City of Alachua

Planning & Community Development Department Staff Report

April 16, 2019

- SUBJECT:** A request to amend the City of Alachua Land Development Regulations (LDRs) as follows: amend Section 5.1.2, Table 5.1-2, Related to the Dimensional Standards within Residential Zoning Districts; amend Section 7.3.1 (B)(1), relating to required standard street improvements for subdivisions; amend Section 7.3.1 (B)(2), relating to design requirements for streets utilizing transitional swales; amend Section 10.2, creating a definition for “transitional swale”.

EXHIBIT "A" TO STAFF REPORT – SAMPLE ROADWAY CROSS SECTION

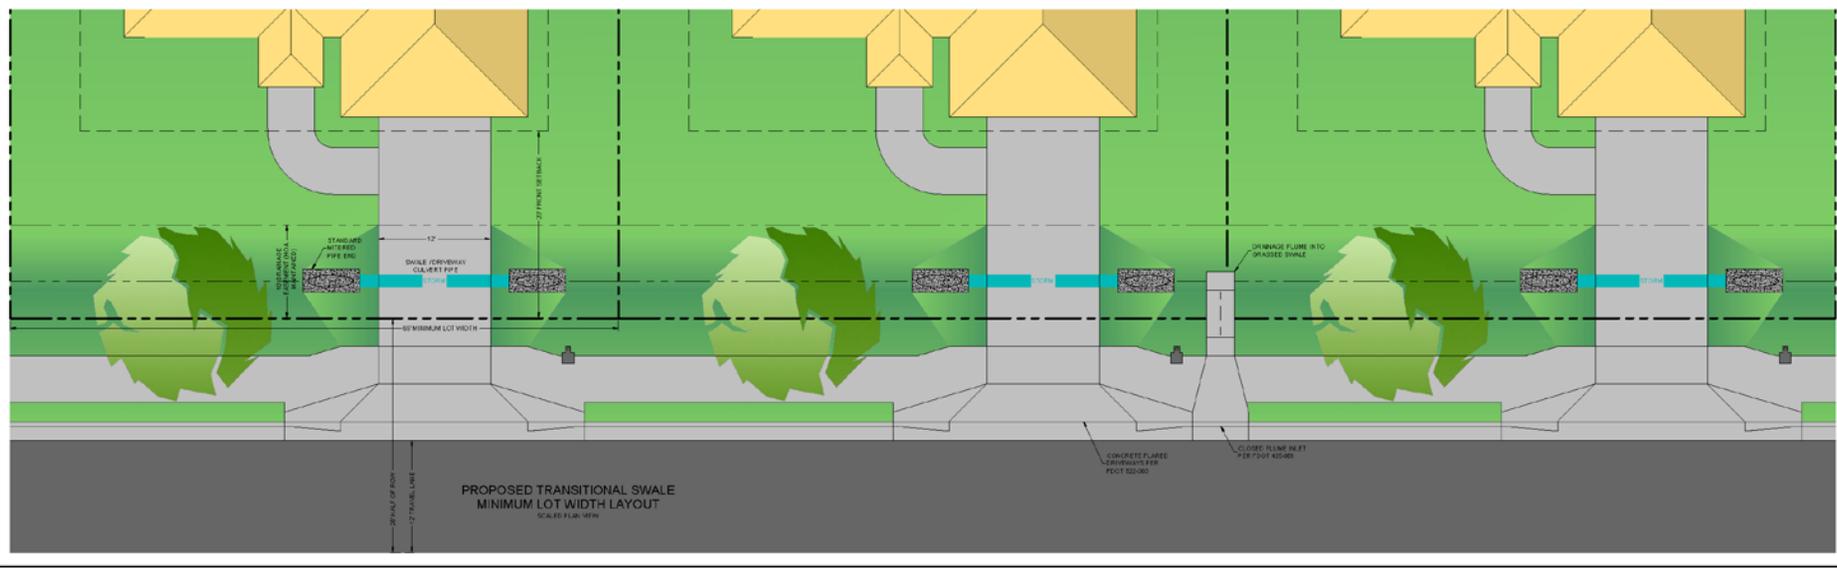
Remaining Comment: Proposed cross section shows a portion of the culvert vertical wall within right-of-way. For clarity of maintenance responsibility, culvert vertical wall must be located completely within drainage easement.

Additionally, proposed cross section shows a portion of the culvert headwall within right-of-way. For clarity of maintenance responsibility, headwall must be located completely within drainage easement.

Comment: Cross section shows 9’ easement for private drainage easement.

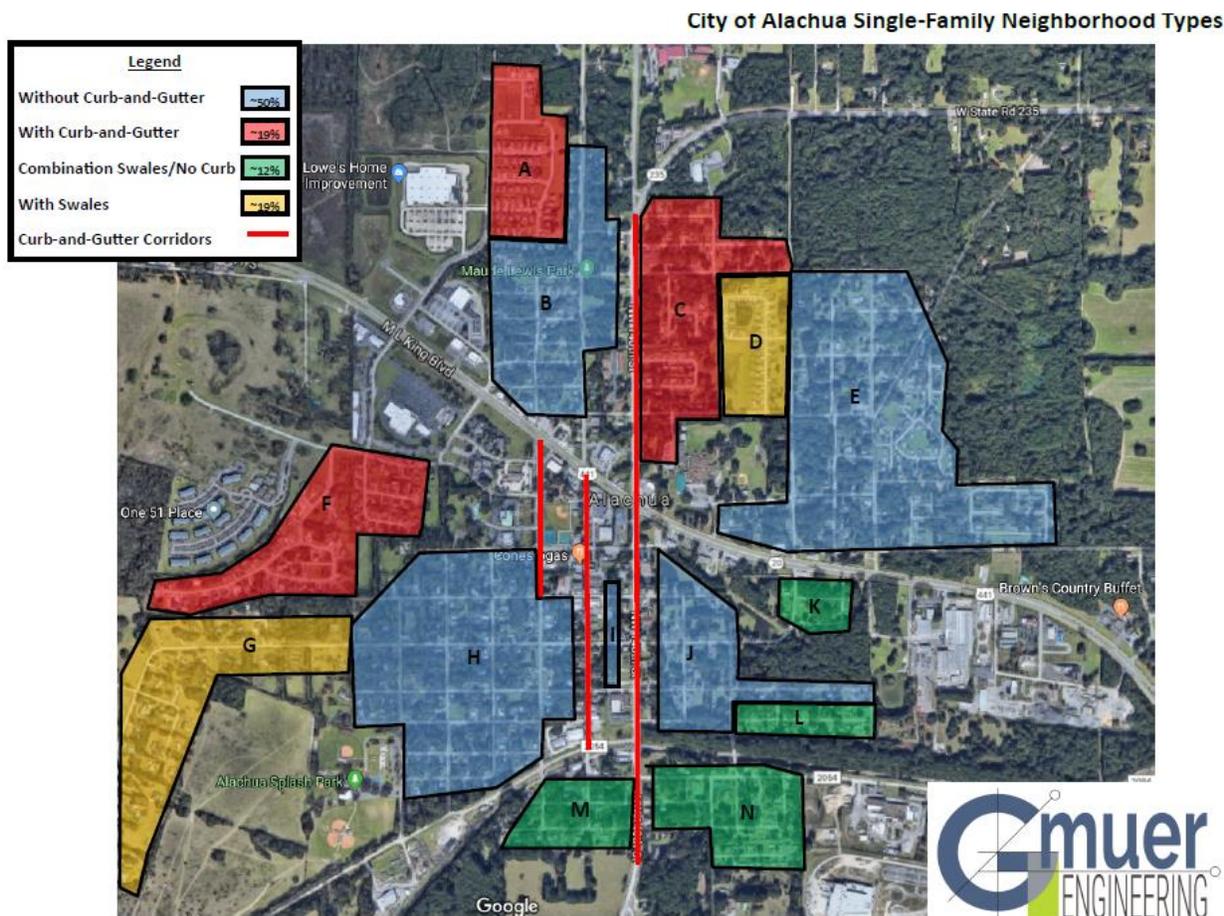
Comment: Response indicates that curb and gutter systems are limited to new development and that a majority of existing development has developed without curb and gutter. As support for this, information has been provided showing existing subareas (Districts) and identifying if they have curb and gutter, swale, or some combination.

In Districts B, H, and J (identified in the above graphic), which are areas without curb and gutter, a majority of the parcels/ lots are significantly larger than the proposed 6,000 square foot size found in the proposed language. A majority of parcels within District B are 75' wide, .25 acre (10,890 square feet) lots. A majority of parcels within District J are 80' to 100' wide, .2 acre (8,712 square feet) lots. And a majority of lots within District H are 63' to 100' wide, .3 acre (13,068 square feet) lots. District E has a variety of lot sizes and widths, but 80' to 100' wide, .25 acre (10, 890 square feet) lots are not uncommon in that District.
